P5028A-03A-S

Safety Service Note

P5028A Keysight Streamline USB Vector Network Analyzer

“POTENTIAL BURN INJURY (HIGH TEMPERATURE) HAZARD”

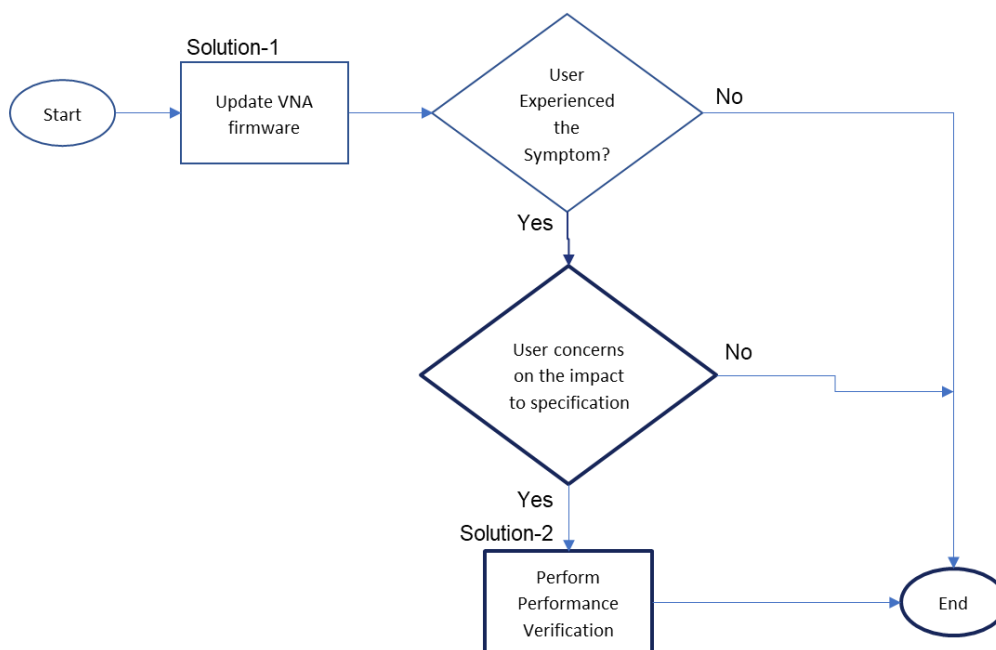
VNA fails to start with the following symptoms.

1. LED indicator (below circle) turns red.
2. cooling fan does not work
3. If user leaves the VNA with this LED indicator red without turning off power switch, it continues to overheat and becomes too hot.

Solution-1: Update VNA firmware by user

Solution-2: Perform Performance Verification by Keysight

1. **Install the latest VNA firmware Rev. A.15.55.14 or newer** on users' controller PC(s).
The latest firmware enhanced the thermal fan control mechanism.
2. Once the latest firmware is installed, proceed with the restart of both **controller PC** and **VNA**.
3. Launch the VNA firmware. Ensure VNA powers up and launches into firmware correctly after firmware update is done.
